ITEM NO.	REQ. QUANTITY	SPARE	TOT.	PART NUMBER	DESCRIPTION	SUPPLIER
PARTS LIST						
UNLESS OTHERWISE SPECIFIED: DIMENSIONS ARE IN INCHES						
DRAWN		4/21/04	DATE	LIGO CALIFORNIA INSTITUTE OF TECHNOLOGY MASSACHUSETTS INSTITUTE OF TECHNOLOGY		
CHECKED				SYSTEM LLO		
				SUB-SYSTEM HEPI		
				NEXT ASSY N/A		
				PART NAME LASTI MANIFOLD 8/8 SUPPLY-RETURN		
TOLERANCES:				SIZE	DWG. NO.	REV
.XX $\pm$ .005				C	D030430-A	A
.XXX $\pm$ .01				SCALE:		SHEET 1 OF 1
ANGULAR $\pm$ 3 DEG				FILE NAME/LOCATION: D030430-A		
MATERIAL: 18 GA S. STL MIRROR						
FINISH: NONE

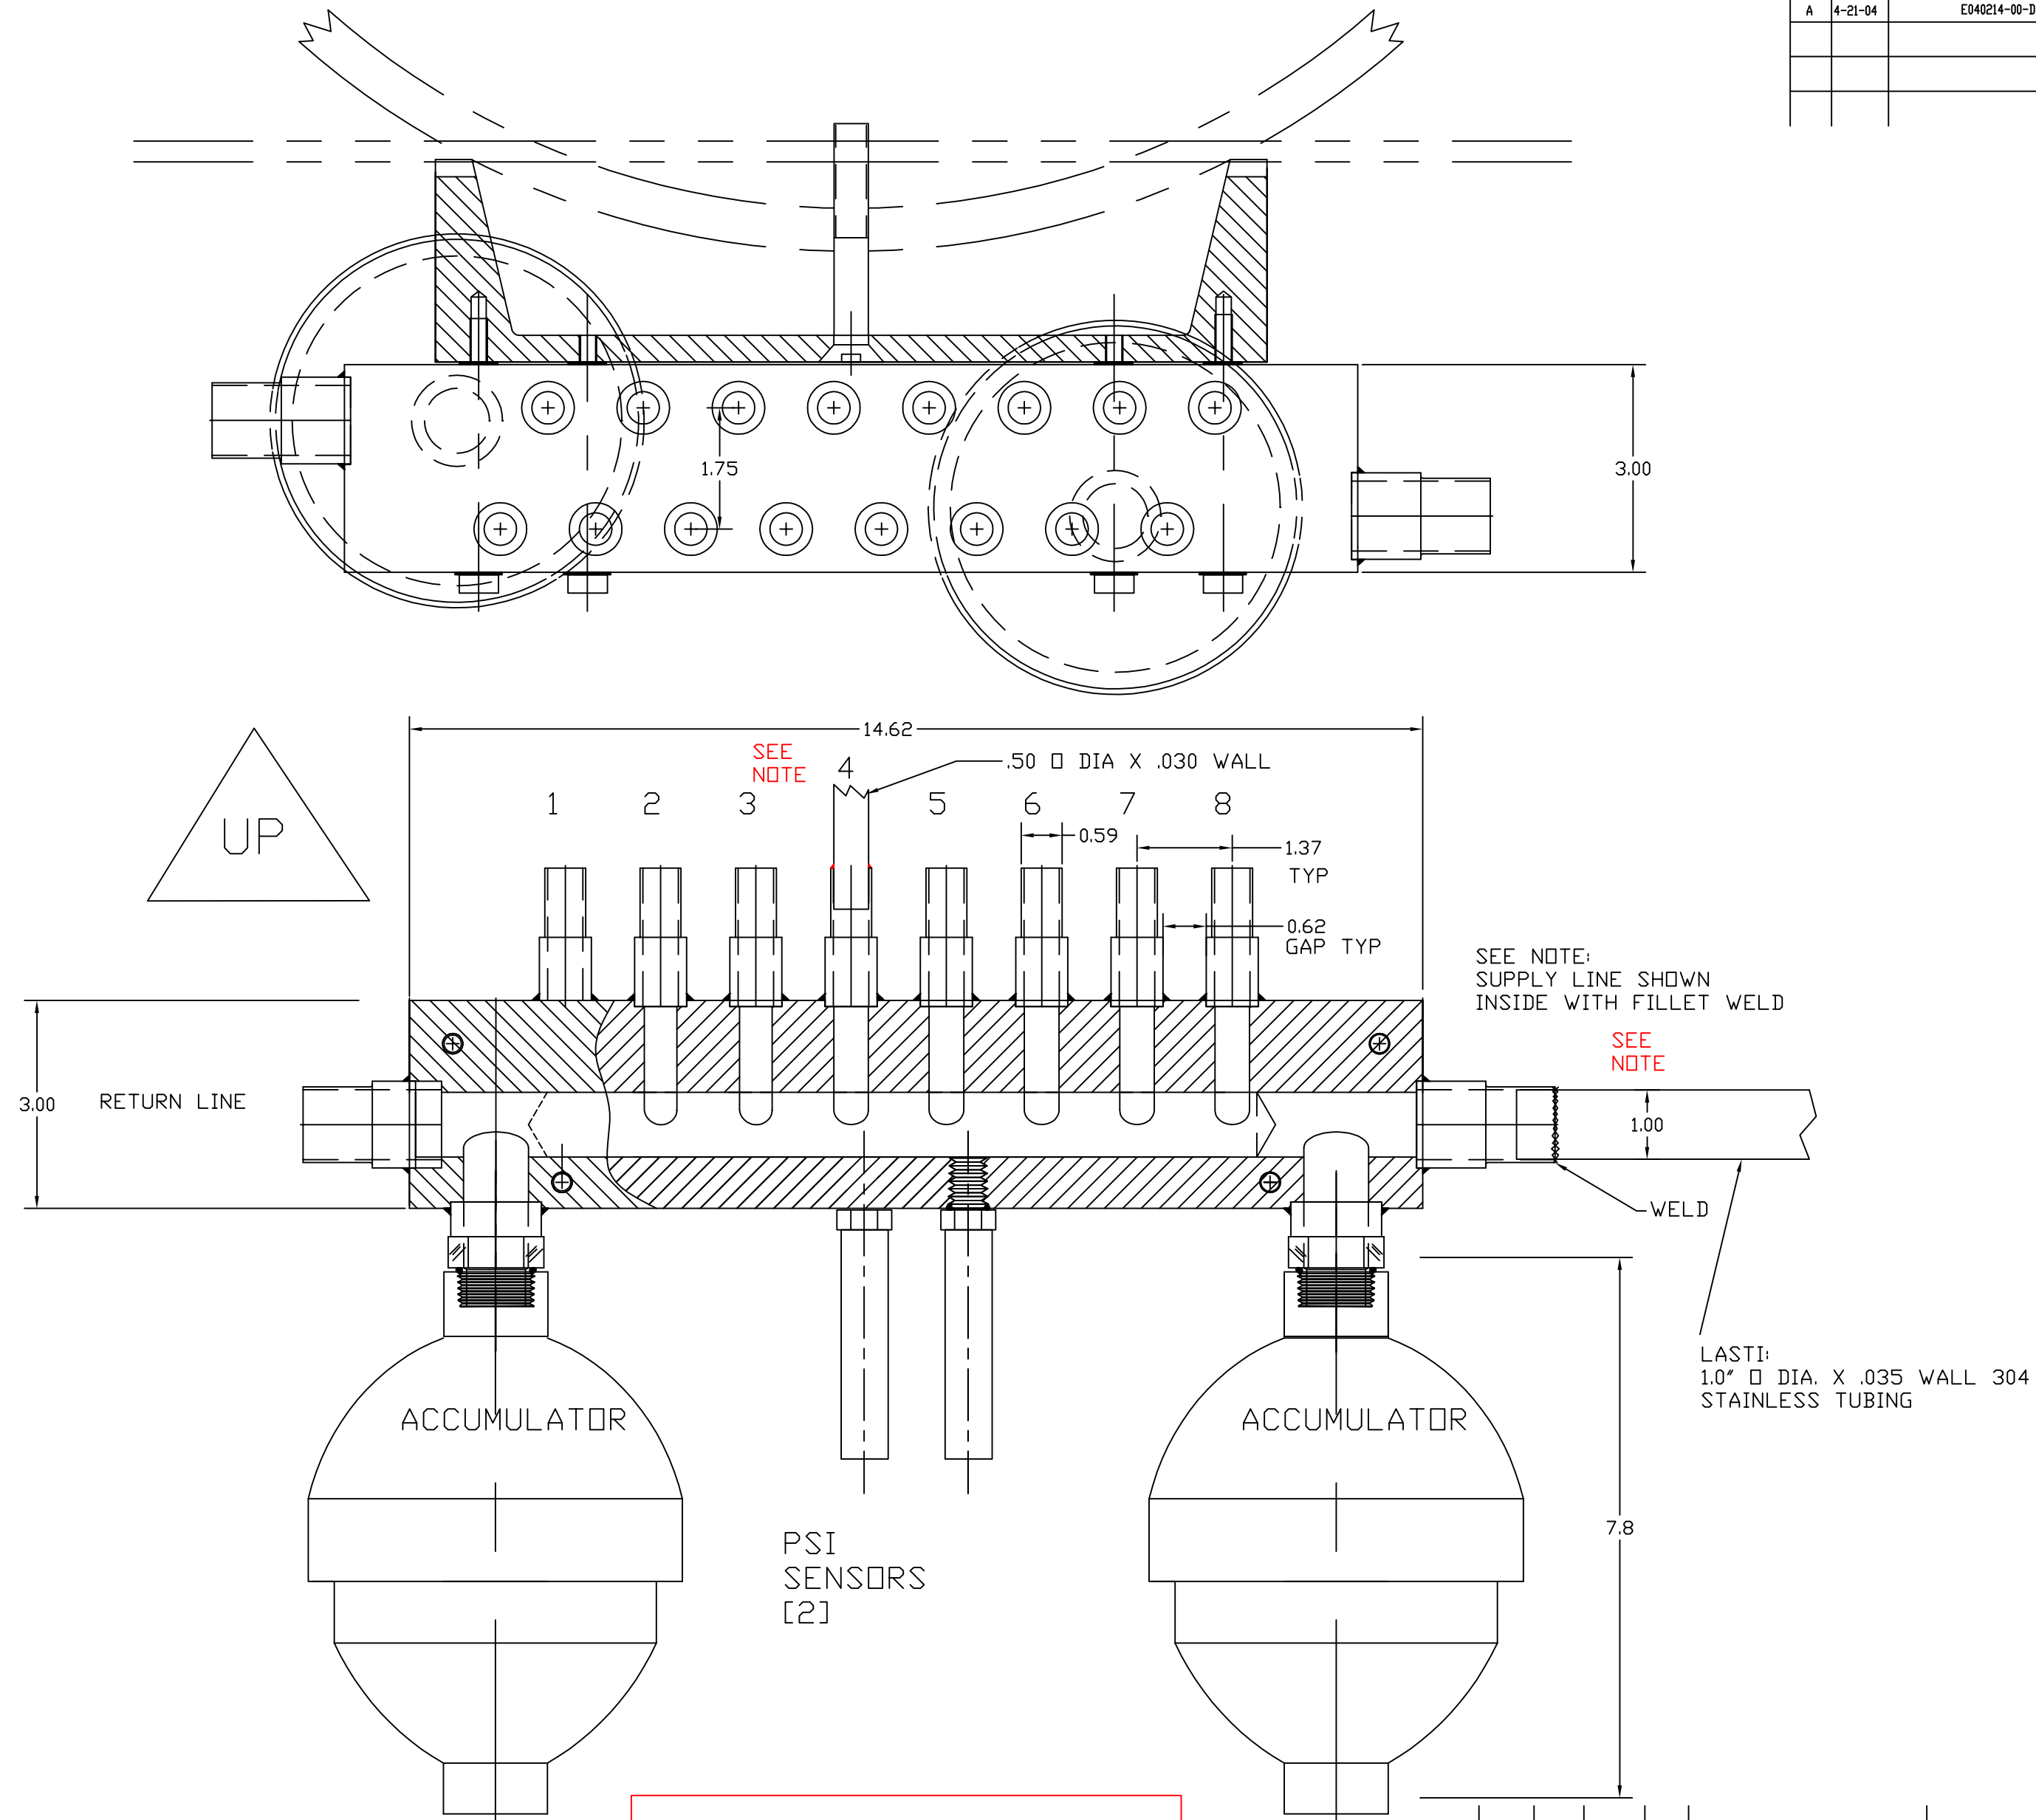
NOTE:  
 THE ORIGINAL MANIFOLD ATTACHMENT  
 STEMS WERE DESIGNED FOR THE  
 PIPES TO SLIP INSIDE AND FILLET  
 WELDED  
 IS THIS METHOD PREFERRED TO A  
 MATCHED  $\square$  DIA. SEAM [BUTT] WELD
